Application Number:	PL/2025/09697
Location:	Birdbush Park, Ludwell, SP7 9HH
Proposal:	Erection of a dwelling

Revised Proposal

I refer to the revised plan, Ground Floor/Block Plan numbered 2671/2A, received in respect of the above planning application.

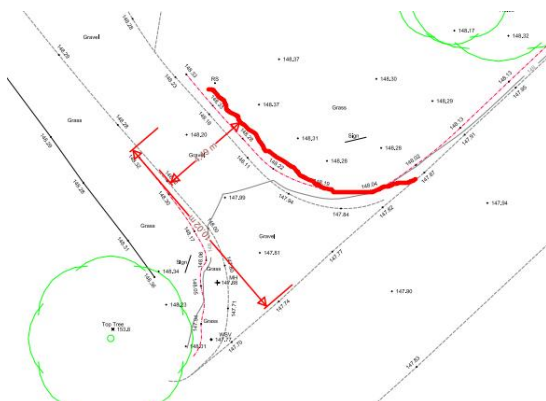
The proposed double garage is now shown of dimensions 6m x 6m which is considered appropriate to be counted as car parking spaces. The surface parking area in front of the garages would accommodate parking for a further two cars, which would now meet the required level of parking for the proposed 4-bedroom dwelling.

In response to the previous highway comments on the width of the private access drive, the plan has been amended to provide a passing bay at a distance of approximately 13m into the driveway.

While the passing bay would be of benefit, it is my view that the widening is most valuable to the southeastern end of the driveway close to the junction, where any conflict of movement as a result of the narrow access drive could impact on the safe use of the junction.

It is noted that a bike rack has been indicated on the revised plan to provide for cycle parking/storage within the site. Such storage would need to be demonstrated to be secure and covered, which could be secured by condition.

I would therefore advise that the access junction itself is widened to provide a 4.5m minimum width which should extend for a distance of a minimum of 10m into the access drive, generally in accordance with the detail below.

The proposed widening, in the form of a passing bays, is not considered appropriate, however, if the access drive were to be widened to 4.5m for the first 10m into the site, there would be no highway objections to the use of the access.
